## 35-TYPE CONVERTER SETS — ADJUSTMENTS

*APPARATUS AFFECTED:* 35A, 35B, 35D, 35E, 35F, 35G and 35H Converter Sets.

- (1) To simplify adjustment methods and requirements.
- (2) To revise and update wiring diagrams.

**4.19 GEAR MECHANISM****(A) INTERMEDIATE SHAFT  
REQUIREMENT**

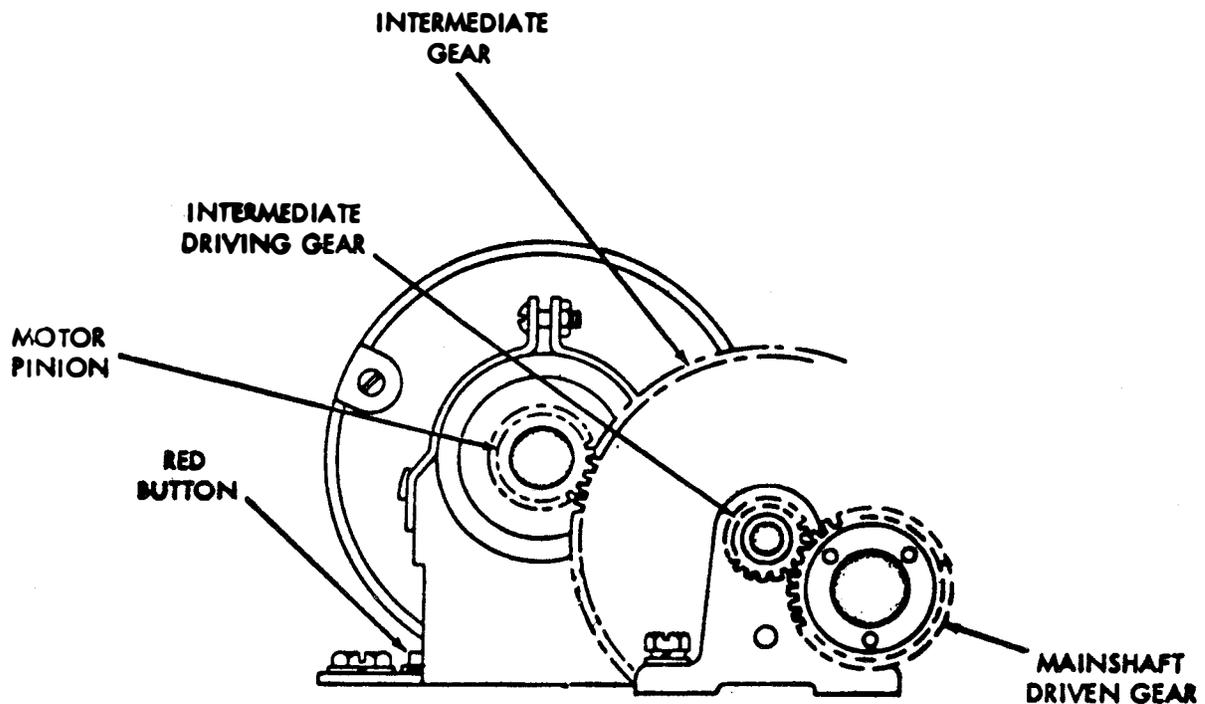
(A) Tape Reader Gear Backlash

The location of subparagraph (A) on page 30 has been changed and will read as subparagraph (B) Tape Reader Gear Backlash.

The requirement (A) Tape Reader Gear Backlash has been changed:

From: "Only a perceptible amount of backlash between main shaft driven gear and intermediate driving gear."

To: "Only a perceptible amount of backlash between main shaft driven gear and intermediate driving gear at point where backlash is least."

(B) Intermediate Shaft

The location of subparagraph (B) on page 30 has been changed and will read as subparagraph (A) Intermediate Shaft.

The requirement of Min. 0.015 inch—Max. 0.020 inch has been deleted.

"To Adjust" of new (A) Intermediate Shaft, has been changed:

From: To Adjust.

Position the intermediate shaft assembly to the forward plate loosened.

To: To Adjust.

Loosen the two intermediate gear bracket screws and position intermediate gear bracket.

The note to subparagraph (B) Intermediate Shaft, has been changed:

From: Note: Intermediate shaft adjustment required only on miniaturized base.

To: Note: In some cases, it may be necessary to loosen the motor mounting screws and position the motor to meet the requirements.

The new requirements are shown on attached sheet which should be used as temporary addendum to page 30, Section 570-106-700.

ONLY A PERCEPTIBLE AMOUNT OF BACKLASH BETWEEN THE MOTOR PINION  
AND INTERMEDIATE GEAR AT POINT WHERE BACKLASH IS LEAST.

LOOSEN THE TWO INTERMEDIATE GEAR BRACKET SCREWS AND POSITION  
INTERMEDIATE GEAR BRACKET.

NOTE: IN SOME CASES IT MAY BE NECESSARY TO LOOSEN THE MOTOR  
MOUNTING SCREWS AND POSITION THE MOTOR TO MEET THE  
REQUIREMENT.

ONLY A PERCEPTIBLE AMOUNT OF BACKLASH BETWEEN MAINSHAFT DRIVEN GEAR  
AND INTERMEDIATE DRIVING GEAR AT POINT WHERE BACKLASH IS LEAST.

LOOSEN THREE TAPE READER MOUNTING SCREWS AND POSITION TAPE READER.
